Sitara™ AM335x ARM® Cortex™-A8 Microprocessors (MPUs) Silicon Revisions 2.1, 2.0, 1.0

Silicon Errata

Literature Number: SPRZ360E
October 2011 – Revised April 2013

Figure 2. RGB888 Mode LCD Controller Output Pin Mapping (LCD_DATA[23:0])

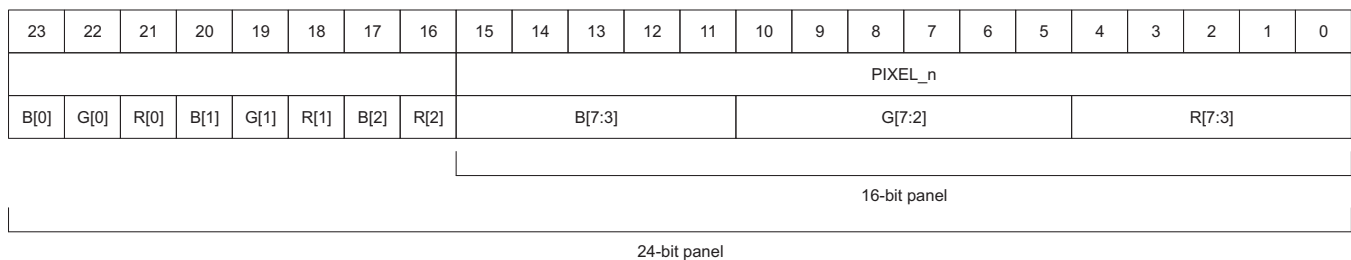
The blue and red color assignments to the LCD data pins are reversed when operating in RGB888 (24bpp) mode compared to RGB565 (16bpp) mode. In order to correctly display RGB888 data from the SGX, or any source formatted as RGB in memory, it is necessary to connect the LCD panel as shown in [Figure 2](#). Using the LCD Controller with this connection scheme limits the use of RGB565 mode. Any data generated for the RGB565 mode requires the red and blue color data values be swapped in order to display the correct color.

Figure 3. RGB565 Mode LCD Controller Output Pin Mapping (LCD_DATA[23:0])

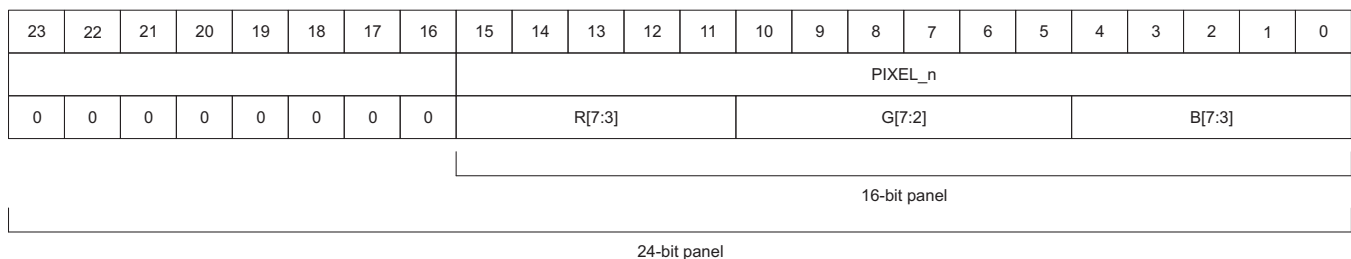
When operating the LCD Controller in RGB565 mode the LCD panel should be connected as shown in [Figure 3](#). Using the LCD Controller with this connection scheme limits the use of RGB888 mode. Any data generated for the RGB888 mode requires the red and blue color data values be swapped in order to display the correct color.

Figure 4. Placement of Series Termination Resistor and Pullup Resistor

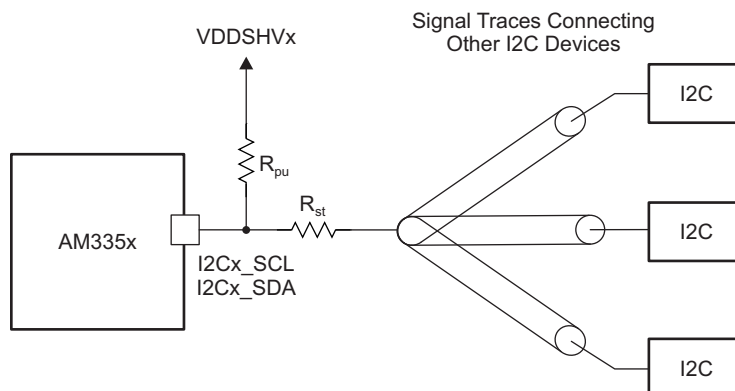
The I2Cx_SDA and I2Cx_SCL outputs are implemented with push-pull 3-state output buffers rather than open-drain output buffers as required by I2C. While it is possible for the push-pull 3-state output buffers to behave as open-drain outputs, an internal timing skew issue causes the outputs to drive a logic-high for a duration of (0–5 ns) before the outputs are disabled. The unexpected high-level pulse will only occur when the SCL or SDA outputs transition from a driven low state to a high-impedance state and there is sufficient internal timing skew on the respective I2C output.

This short high-level pulse injects energy in the I2C signals traces, which causes the I2C signals to sustain a period of ringing as a result of multiple transmission line reflections. This ringing should not cause an issue on the SDA signal because it only occurs at times when SDA is expected to be changing logic levels and the ringing will have time to damp before data is latched by the receiving device. The ringing may have enough amplitude to cross the SCL input buffer switching threshold several times during the first few nanoseconds of this ringing period, which may cause clock glitches. This ringing should not cause a problem if the amplitude is damped within the first 50 ns because I2C devices are required to filter their SCL inputs to remove clock glitches. Therefore, it is important to design the PCB signal traces to limit the duration of the ringing to less than 50 ns. One possible solution is to insert series termination resistors near the AM335x SCL and SDA terminals to attenuate transmission line reflections.

Insert series termination resistors on the SCL and SDA signals and locate them near the AM335x SCL and SDA terminals. The SCL and SDA pullup resistors should also be located near the AM335x SCL and SDA terminals. The placement of the series termination resistor and pullup resistor should be connected as shown in [Figure 4](#).
